## 12<sup>th</sup> Meeting of the IHO (S-100WG) S-101 Project Team

## S-101 Documentation and FC GitHub Open Issues Impacting on the Feature Catalogue - Summary

Agenda Item 05.1A

## IHO ISSUE #118: ADD INTHEWATER AS AN ALLOWABLE ATTRIBUTE FOR FEATURE BUILTUPAREA

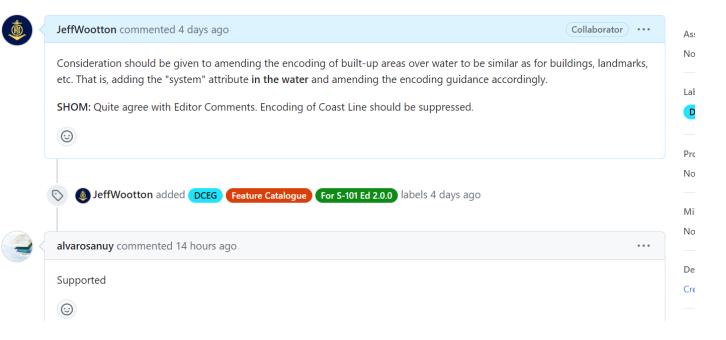
Discussed at S-101PT12 in association with Paper S-101PT12-06.9. Action assigned to apply this change. Add inTheWater as an allowable attribute for feature BuiltUpArea

• <u>Recommendation</u>: May be added for Edition 2.0.0 but is a lower priority so only include in Edition 2.0.0 if time allows.

## IHO ISSUE #120: NEW FEATURE DEPTHDISCONTINUITY

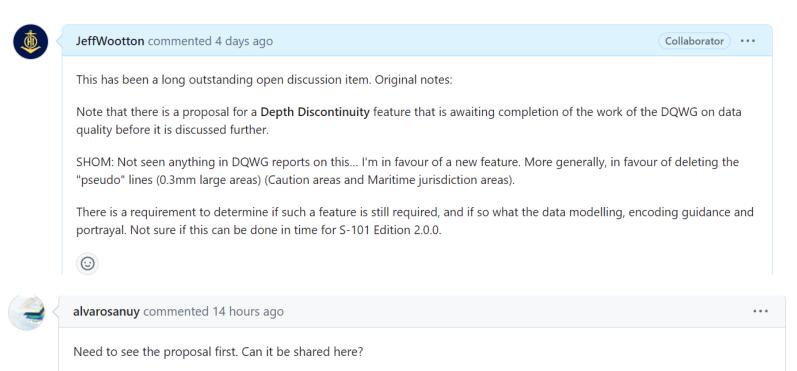
- S-101PT Chair: I think this has come up previously as it could certainly be added after 2.0.0 propose make this post 2.0.0 and continue to review.
- Re: Alvaro comment: Full proposal was pending based on outcome of DQWG discussions

• **Recommendation:** Discuss further post-Edition 2.0.0.
